Product Safety Recall

A202298320 Rear Door May Open Unexpectedly

Release Date: April 2020

Revision: 01

4534757

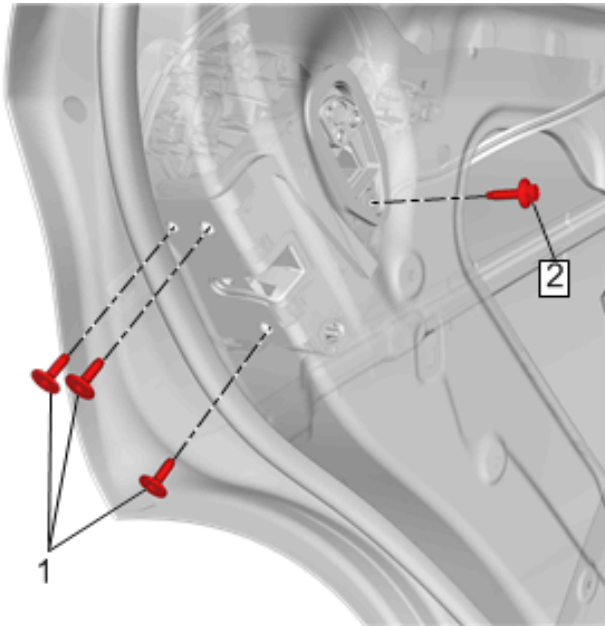
IMPORTANT: The rear door latch fasteners (1) are one-time use components. Replace the six (three per side) rear door latch bolts with new bolts when reinstalling the latch assemblies. The inner attachment fastener (2) can be reused.

NOTE: It is not necessary to replace the belt line molding clips.

1. Replace the left and right rear door inside handle cable. Refer to *Rear Side Door Inside Handle Cable Replacement* in SI.
2. Verify the function of the inside door handles.
